NP0 - MP 3010

MP3010 – GM option code NQO

TRANSFER CASE IDENTIFICATION FIRST DESIGN VS. SECOND DESIGN

INTERIM MODEL YEAR DESIGN CHANGE - NQF/NQG/NQH/NPO FRONT OUTPUT SHAFT, DEFLECTOR, SEAL

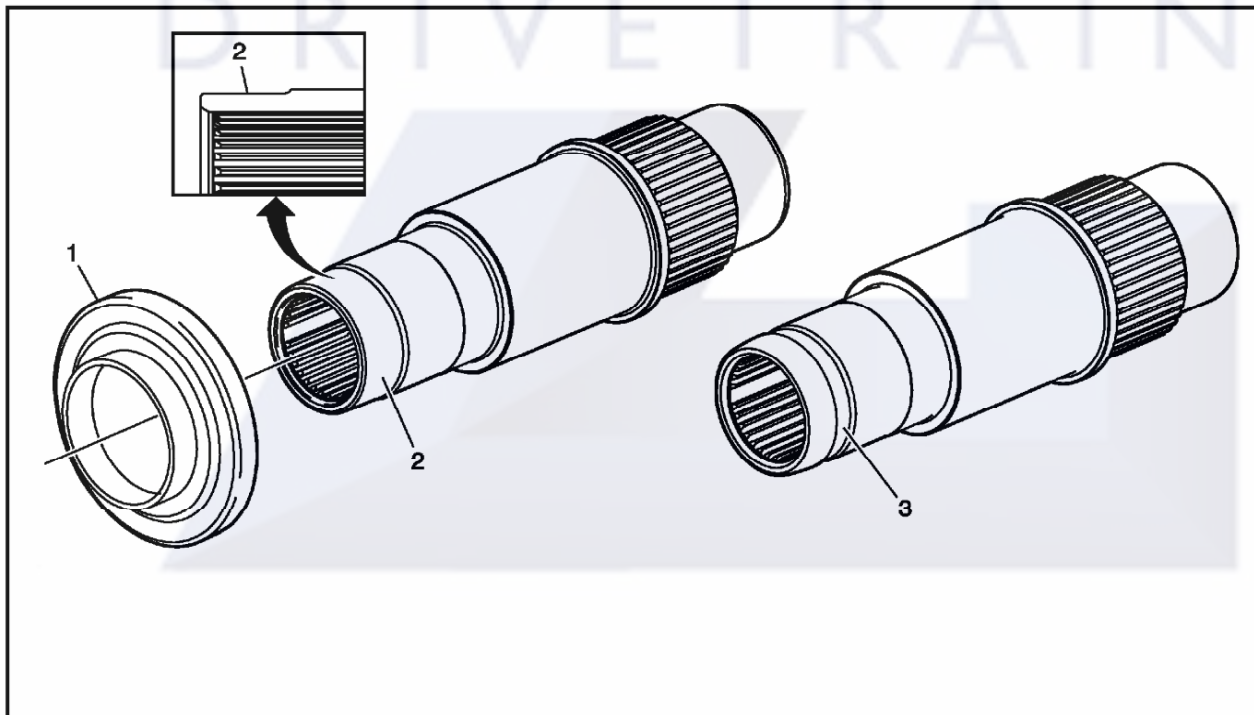
Interim 2012 model year, a new design front output shaft deflector (3) was implemented into production for second design NQF-HD/SHD and NQG-HD applications. First design 2011 model year NQF and NQG applications can be identified as not having the deflector on the front output shaft.

For service, the new design front output shaft, deflector and new design seal may be installed on current and prior model year Magna NQF-HD/SHD, NQG-LD/HD, NQH-LD/HD and NP0 applications providing the new design front output shaft is also installed. The front output shaft deflector is to be installed using the **J 8092** driver handle (1) and **DT 50649** seal installer (2).

The new design deflector (1) can be installed onto all current and prior model year Magna RPOs NQF, NQG, NQH and NPO applications providing the new design front output shaft (2) is also installed. Second design front output shafts can be identified by the machined area on the OD output end of the shaft (2). First design front output shafts can be identified by the dust boot clamp groove (3) located at the OD output end of the shaft. The new design slinger will NOT install onto the first design shafts.

INTERIM MODEL YEAR DESIGN CHANGE - NQG HIGH/LOW SHIFT FORK, FORK PAD, AND HIGH/LOW CLUTCH

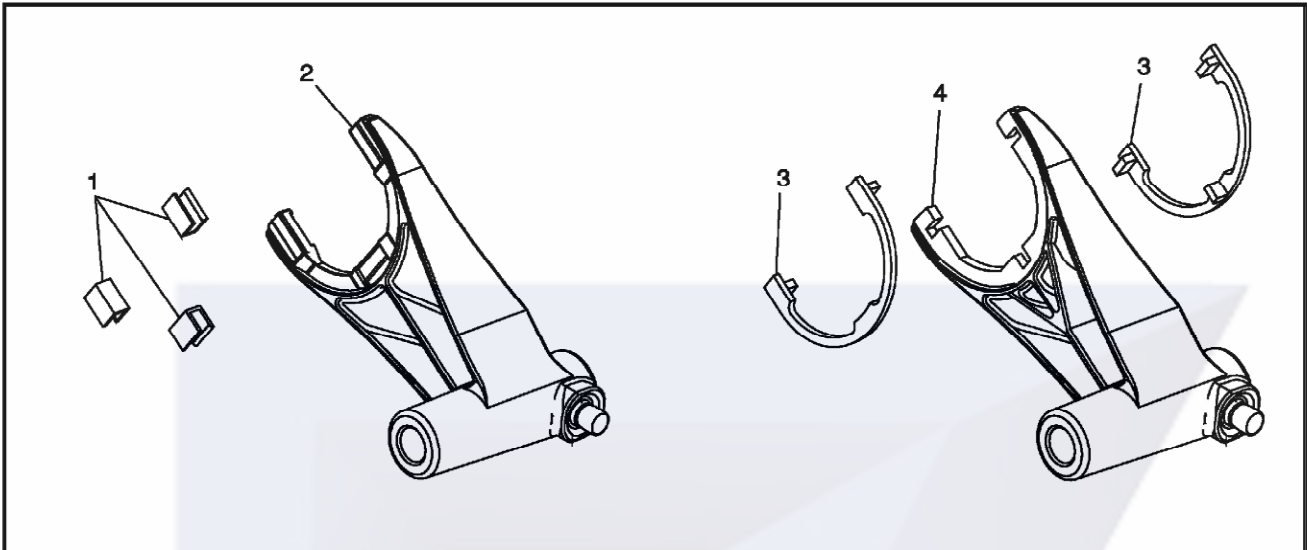
Interim 2012 model year the High/Low shift fork, fork pad and High/Low clutch design changed. The first design forks (2) can be identified as having three flat un-notched fork pad areas with three separate fork pads (1). The second design forks (4) can be identified as having a half-round shaped pad area with three notches for pad orientation and installation and upper and lower half-round fork pads (3). The second design shift fork (4) and pads (3) are the only design available for service and must be used with the second design High/Low clutch.

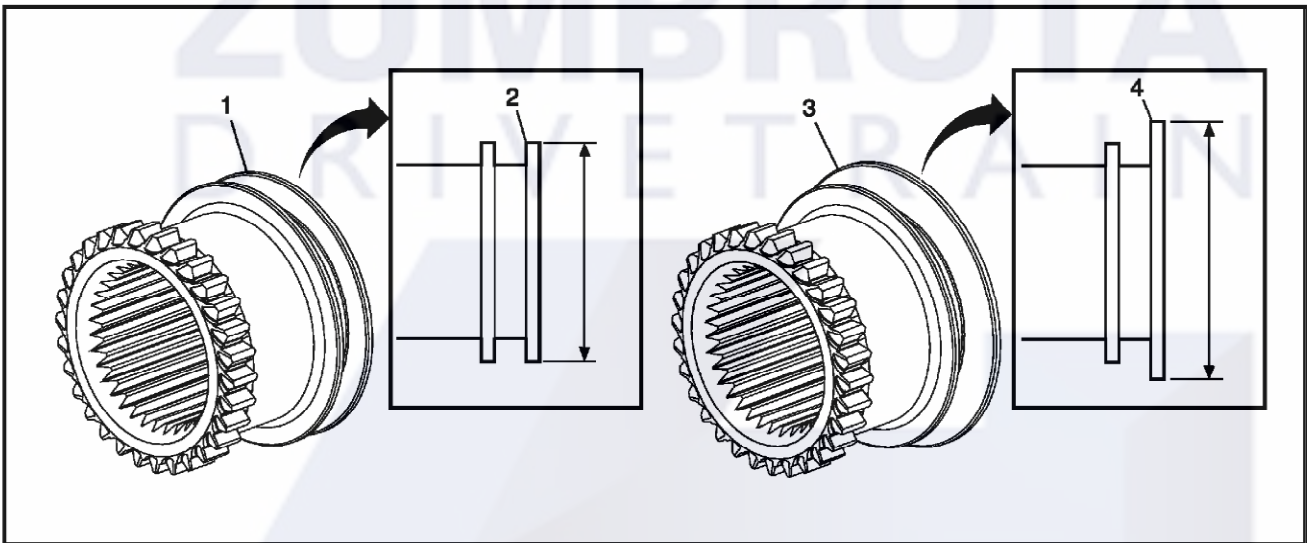
Interim 2012 model year the High/Low shift fork, fork pad and High/Low clutch design changed. The first design high/low clutch (1) can be identified by having a 73 mm (2.87 in) OD rear flange (2). The second design high/low clutch (3) can be identified by having a 76 mm (2.99 in) OD rear flange (4).

- The first design 73 mm (2.87 in) high/low clutch may NOT be used with the second design fork and pad.
- The second design 76 mm (2.99 in) high/low clutch must be used with the second design fork and fork pad.
- The second design 76 mm (2.99 in) high/low clutch may also be used with the first design fork and pad if first design fork replacement is not required.

SERVICE PARTS RELEASE USAGE CHANGE-NQH/NPO CONTROL ACTUATOR LEVERS

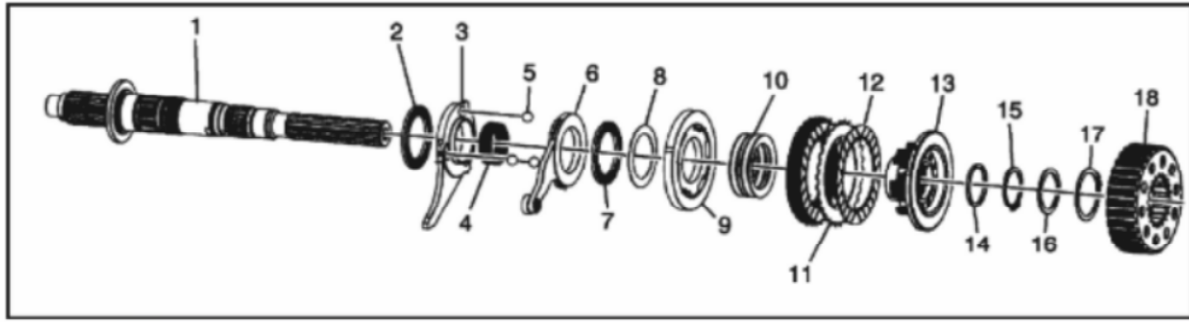
Light Duty (LD) 2007-2010 MP3023-NQH and 2010 MP3010-NP0 production transfer cases are built with LD control actuator levers (3 and 6) and are used with 13 mm (0.52 in) diameter control actuator lever balls (5).

Heavy duty (HD) 2007-2010 MP3024-NQH production transfer cases are built with HD control actuator levers (3 and 6) and are used with Heavy 10 mm (0.39 in) control actuator lever balls.

When replacement of one or both of the LD control actuator levers is required, it is necessary to replace both of the levers and all three balls with the HD components as a set. It is also necessary to re-measure and adjust clutch pack clearances as required and to perform the Transfer Case High/Low Clutch Reset. Refer to Measuring/Adjusting Clutch Assembly Height in Transfer Case Assemble, Transfer Case Description and Operation and Transfer Case High/Low Clutch Reset. Heavy duty (HD) components are the only parts available for service.

INTERIM MODEL YEAR DESIGN CHANGE - NQF/NQG/NQH FRONT CASE HALF ASSEMBLY, INPUT SHAFT, PLANETARY CARRIER HIGH/LOW CLUTCH

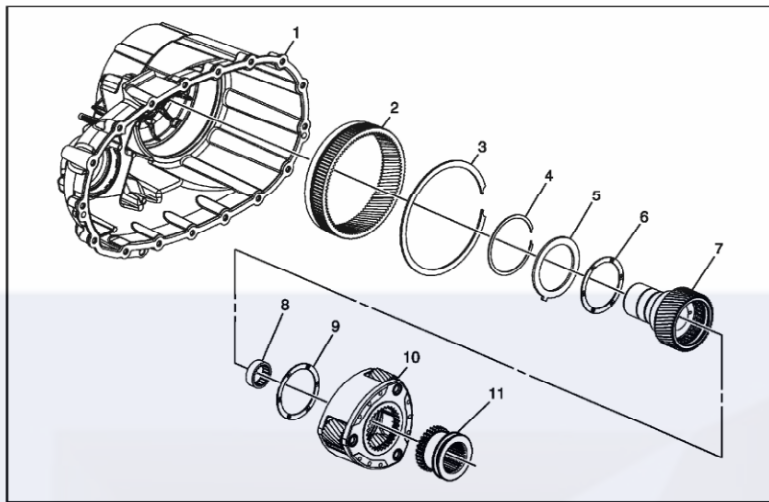
Interim 2012 model year for Magna light-duty and heavy-duty transfer case RPOs NQF / NQG / NQH, a second-design front case half assembly, planetary internal gear, gear retaining ring, locking plate, thrust washer-front, input shaft, pilot bearing, thrust washer-rear, high/low planetary carrier and high/low clutch were implemented into second-design assemblies.

The second-design light duty (LD), heavy duty (HD), and super-heavy duty (SHD) applications have a reduced OD dimension carrier and the second-design planetary internal gear has a reduced ID dimension. The planetary internal gear is a press-fit non-serviceable component and must be serviced with the front case half assembly. In service it is possible that a new or remanufactured transfer case may contain first or second-design content.

If a second-design transfer case has been installed into a vehicle that originally contained a first-design assembly, TCCM reprogramming is not required.

FRONT CASE HALF IDENTIFICATION

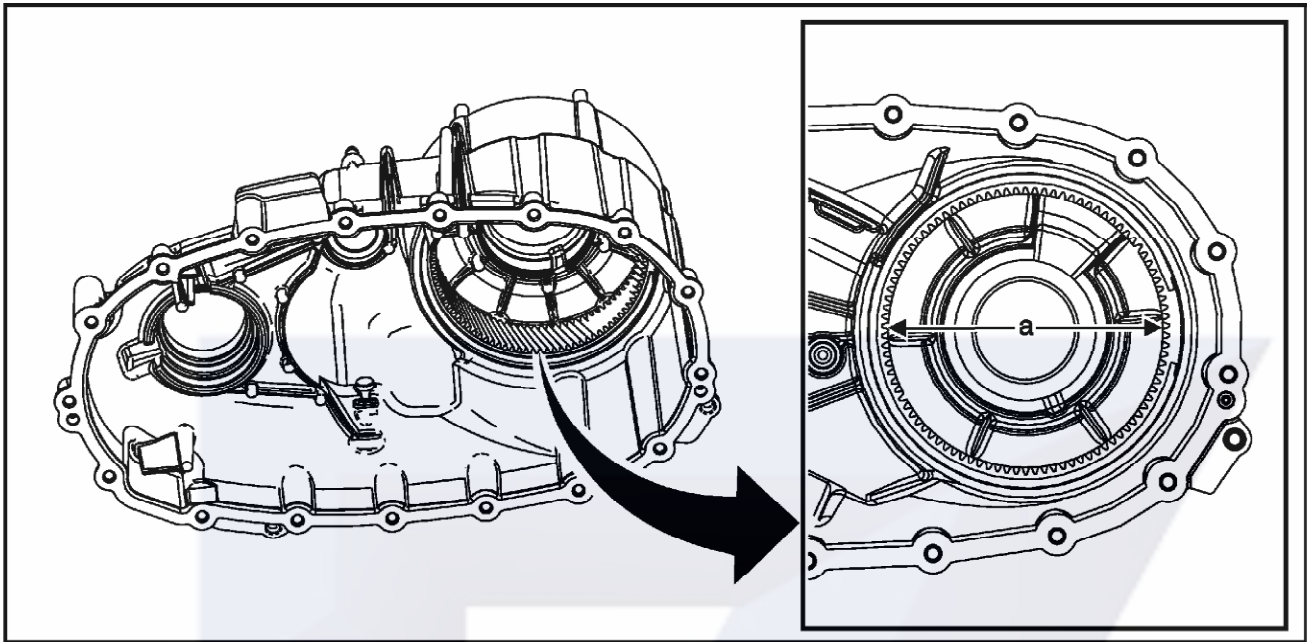
The first design front case half assembly can be identified as having an internal gear that is a 94 tooth design with an inside diameter (a) of 148.5 mm (5.85 in).

The second design front case half assembly can be identified as having an internal gear that is a 91 tooth design with an inside diameter (a) of 142 mm (5.59 in).

INPUT SHAFT IDENTIFICATION

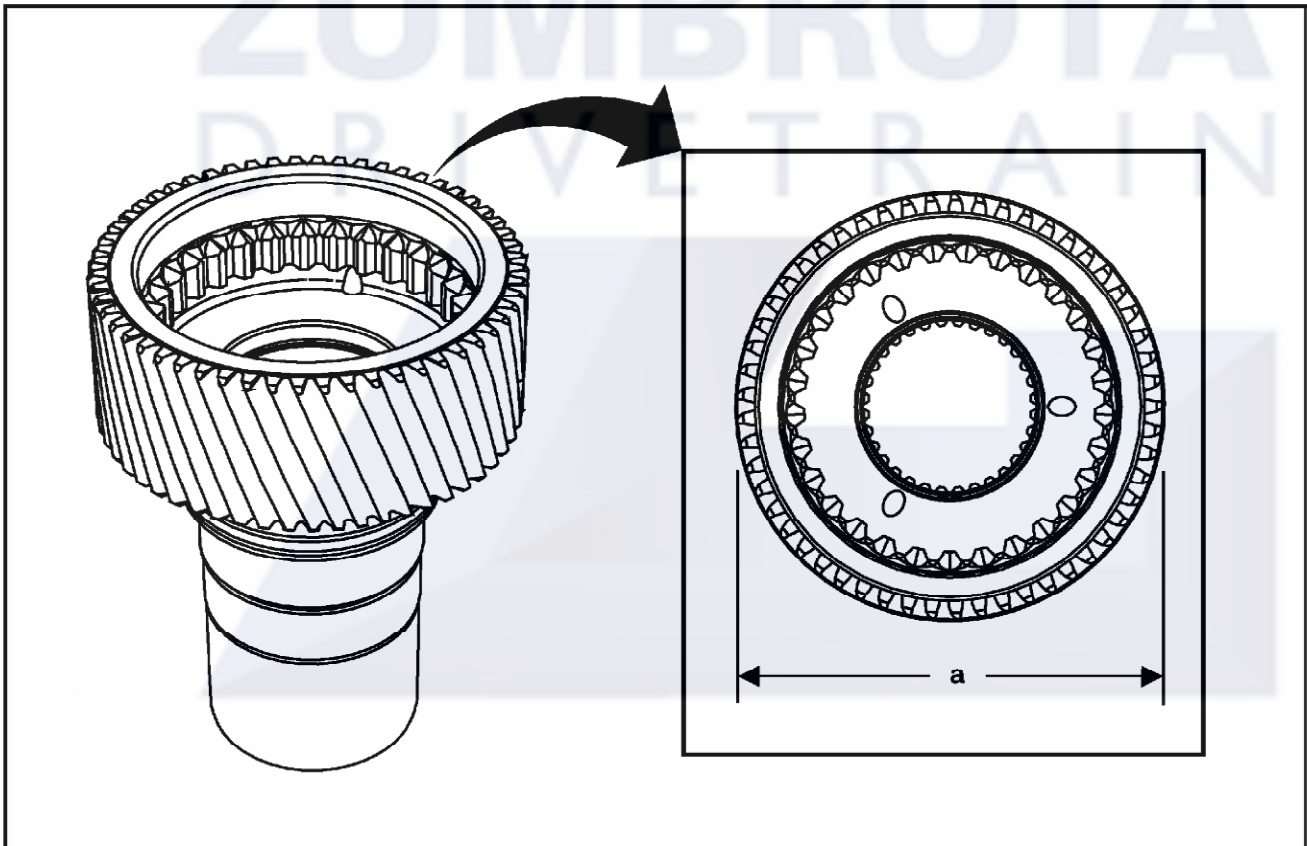
The first design input shaft can be identified as a 56 tooth design with an outside diameter (a) of 91.4 mm (3.60 in).

The second design input shaft can be identified as a 53 tooth design with an outside diameter (a) of 87.50 mm (3.44 in).

HIGH/LOW PLANETARY CARRIER ASSEMBLY IDENTIFICATION

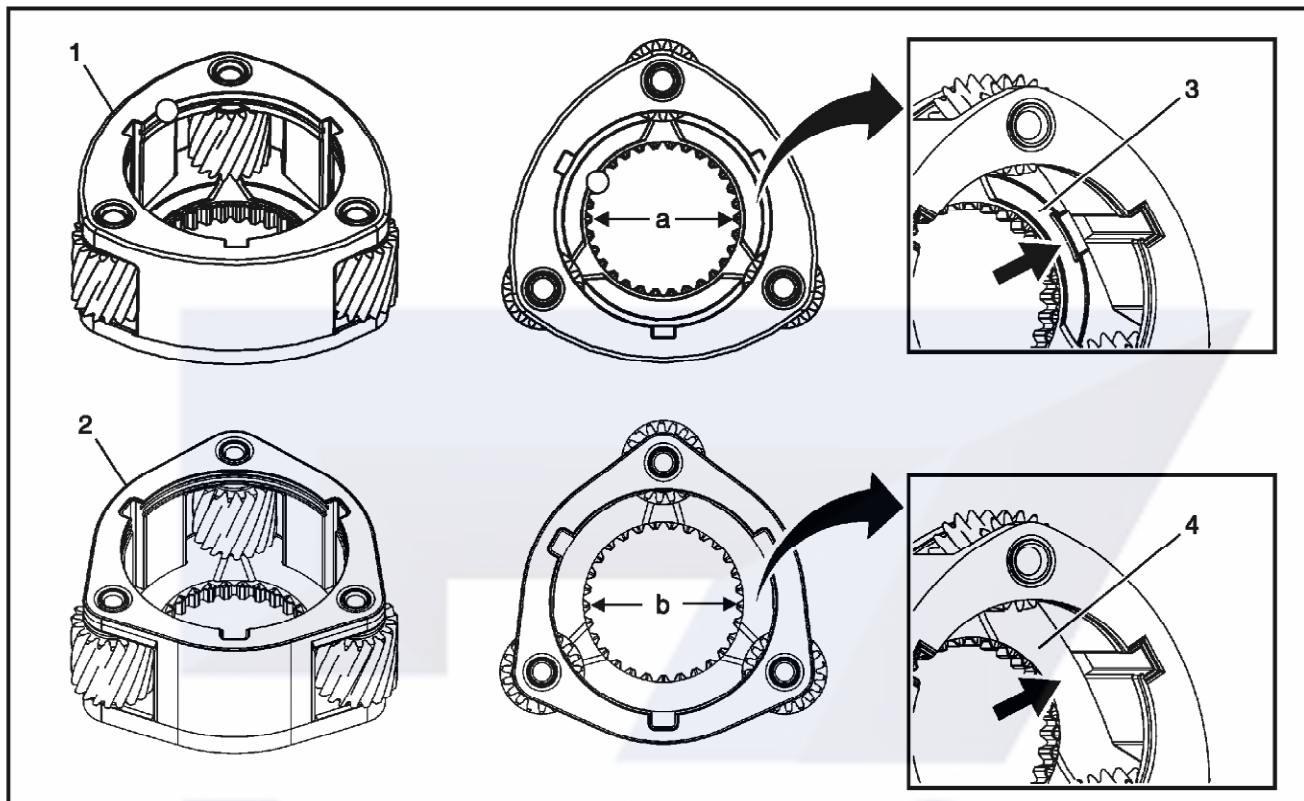
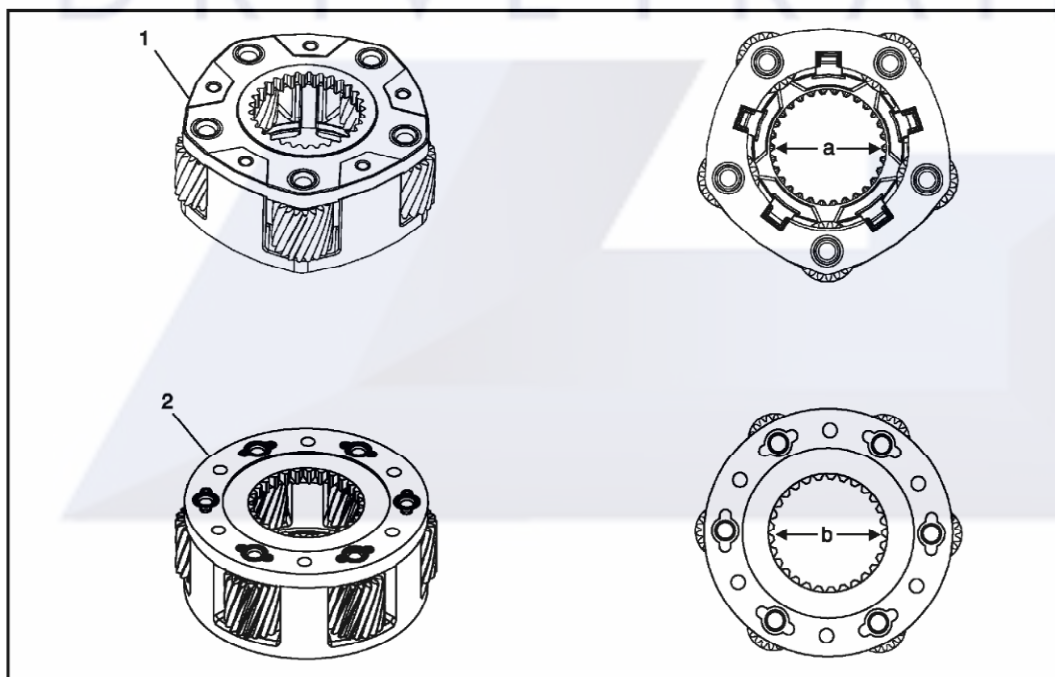
The first-design light-duty 3-pin high/low planetary carrier (1) can be identified as having a 30 tooth design with an inside diameter (a) of 61.3 mm (2.41 in). In addition, the first-design carrier can also be identified by the presence of a recessed washer pocket (3) at the rear thrust washer location.

The second-design light-duty 3-pin high/low planetary carrier (2) can be identified as having a 29 tooth design with an inside diameter (b) of 60.2 mm (2.37 in). In addition, the second-design carrier can also be identified by the lack of a recessed washer pocket (4) at the rear thrust washer location.

The first-design heavy-duty 5-pin high/low planetary carrier (1) can be identified as having 5 pinions and a 30 tooth design with an inside diameter (a) of 61.3 mm (2.41 in).

The second-design heavy-duty 6-pin high/low planetary carrier (2) can be identified as having 6 pinions and a 29 tooth design with an inside diameter (b) of 60.2 mm (2.37 in).

HIGH/LOW CLUTCH

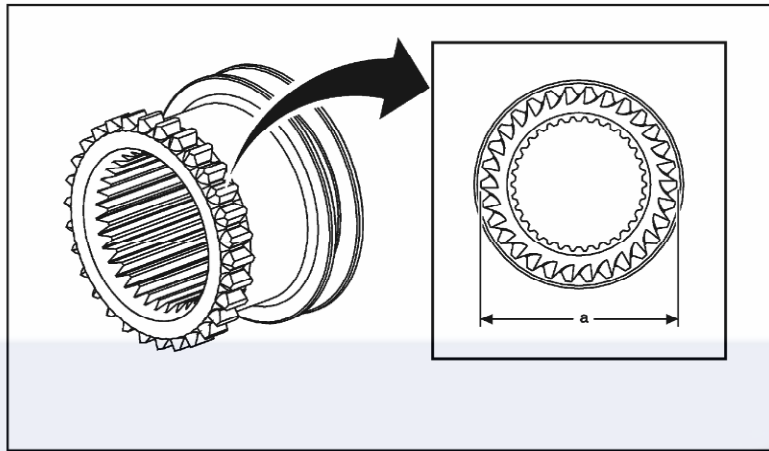
The first design high/low clutch can be identified as having a 30 tooth design with a gear tooth outside diameter (a) of 65.50 mm (2.58 in).

The second design high/low clutch can be identified as having a 29 tooth design with a gear tooth outside diameter (a) of 63.25 mm (2.49 in).

COMPONENT REPLACEMENT - CONVERSION FROM FIRST DESIGN TO SECOND DESIGN

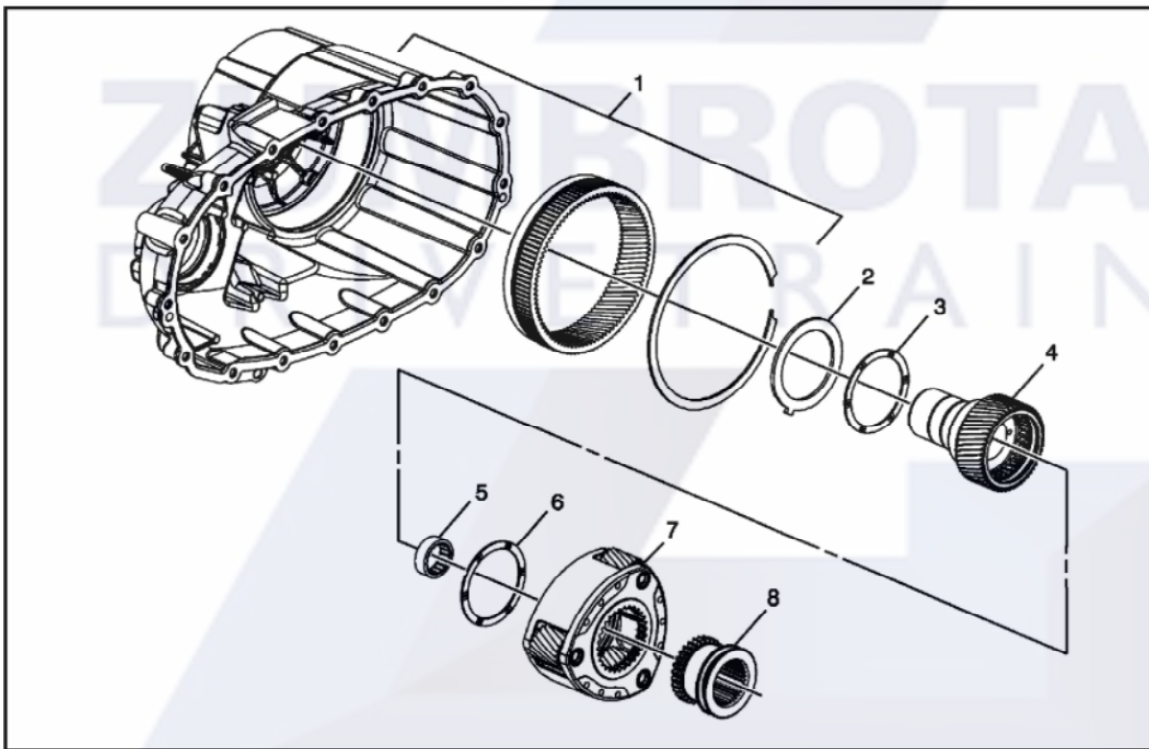
It is possible to repair a first-design assembly using second-design components. Refer to the parts catalog and the tables above for component part number clarification.

NOTE: First-design LD components are shown in the view above.

When servicing a first-design assembly with second-design components, the following components **MUST** be replaced as a group:

1. Front Case Half Assembly - with internal gear and retaining ring
2. Locking Plate
3. Thrust Washer (front)
4. Input Shaft
5. Pilot Bearing
6. Thrust Washer (rear)
7. Planetary Carrier Assembly
8. High/Low Clutch

2014 NQH/NPO/NQG-LD Model Year Design Change - Addition of a Tuned Vibration Adapter (dampener) for V-6 Engine RPO LV3 Applications

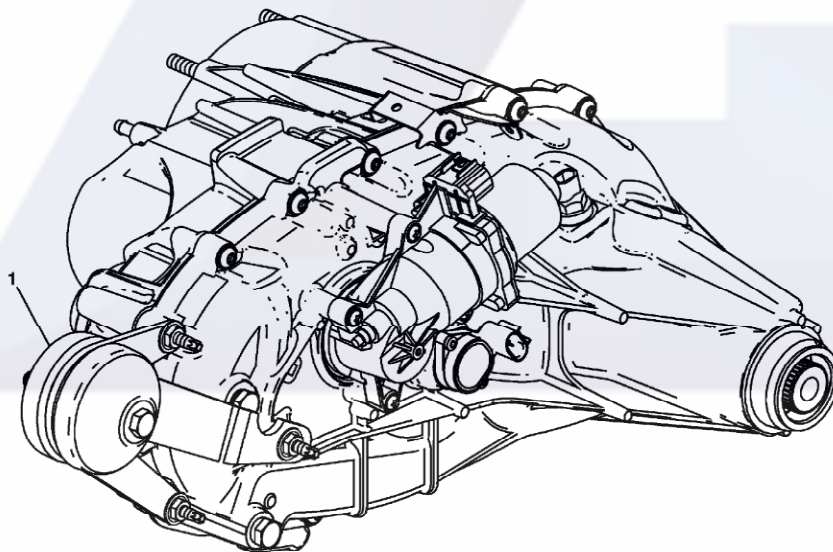
Beginning in 2014 model year for V-6 engine RPO LV3 applications, a dampener (1) has been added to the exterior of the NQH and NQG-LD transfer cases.
